**RE: SOFTBALL FIELD IMPROVEMENTS
WAKONDA, SOUTH DAKOTA
SPN #16579**

ADDENDUM NUMBER 1

The following modifications are to be made to the plans and specifications for the Softball Field Improvements Project.

4' TALL CHAIN-LINK FENCE DETAIL

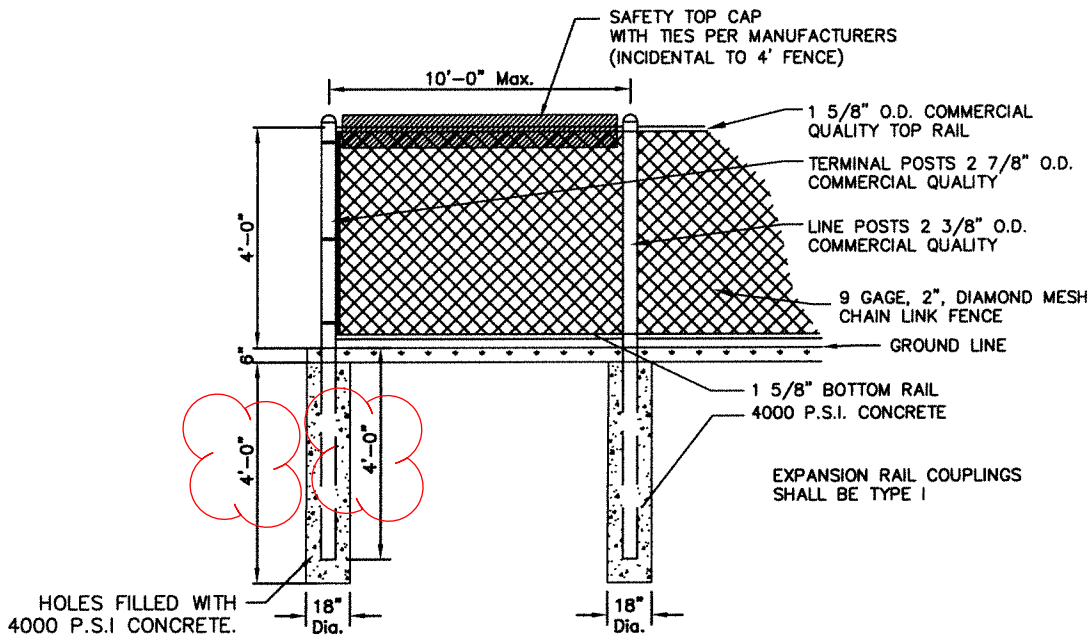
The 4' Tall Chain-Link Fence Detail found on sheet 15 shall be deleted in its entirety and replaced with the attached exhibit. This addendum extends the footing depth from 2 feet to 4 feet.
